AXC F 2152 – CHANGE NOTES

Change notes for the AXC F 2152 controller

Application note

108427_en_41

Left-alignable INTERBUS master

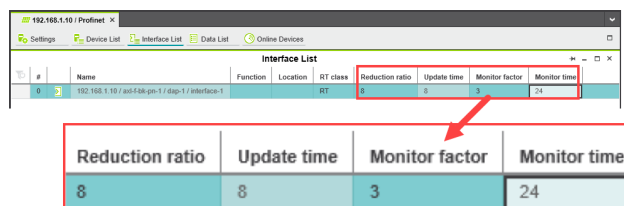
The controller now supports left-alignment of the INTERBUS AXC F XT IB master (Order No. 2403018).

Figure 2 Select Trigger task

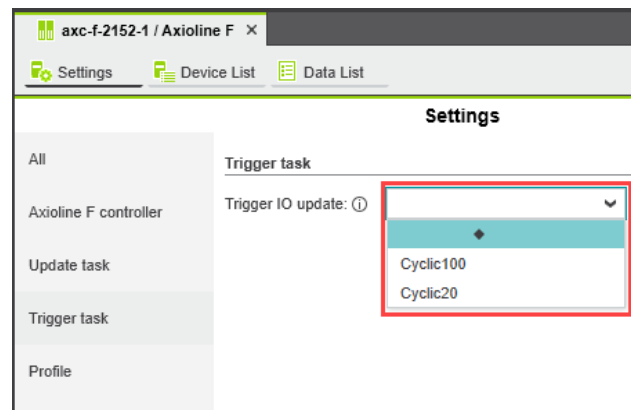
- Select the “Trigger task” view in the “Settings” editor.
- In the drop-down list, select the task that is to trigger the Axioline F I/O data update.

If you do not select a task, the update will occur by default every 50 ms.
